Product / Process Change Notification (PCN)	
<input type="checkbox"/> Major change <input checked="" type="checkbox"/> Minor change	
PCN #: PCN_FrqXTAL_20230301 Affected Series: WE-XTAL; 830025159 PCN Date: December 01, 2022 Effective Date: March 01, 2023	Change Category: <input type="checkbox"/> Equipment / Location <input type="checkbox"/> General Data <input type="checkbox"/> Material <input type="checkbox"/> Process <input type="checkbox"/> Product Design <input checked="" type="checkbox"/> Shipping / Packaging <input type="checkbox"/> Supplier <input type="checkbox"/> Software
Contact: Product Management Phone: +49 (0) 7942 - 945 5001 Fax: +49 (0) 7942 - 945 5179 E-Mail: pcn.eisos@we-online.com	Data Sheet Change: <input type="checkbox"/> Yes <input checked="" type="checkbox"/> No Attachment: <input type="checkbox"/> Yes <input checked="" type="checkbox"/> No
Description and purpose of change: To improve the processability, Würth Elektronik will change the dimensions of the carrier tape. All products with date code 2022-10-14 or later, will be affected by this change. There will be no change in form, fit, function, quality or reliability of the product.

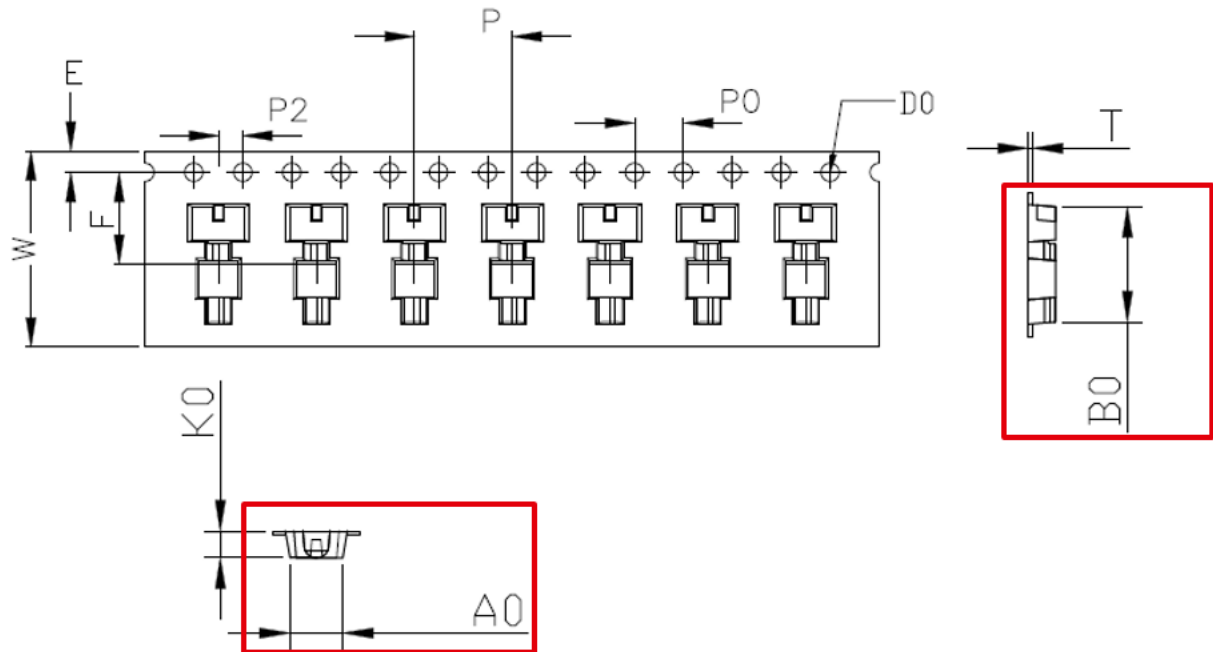
Detail of Change: To prevent the product from getting stuck in the tape, the dimension of the tape cavity is changed.

Before Change	After Change
A0	4.30±0.10 mm	4.50±0.10 mm
B0	9.40±0.10 mm	9.55±0.10 mm
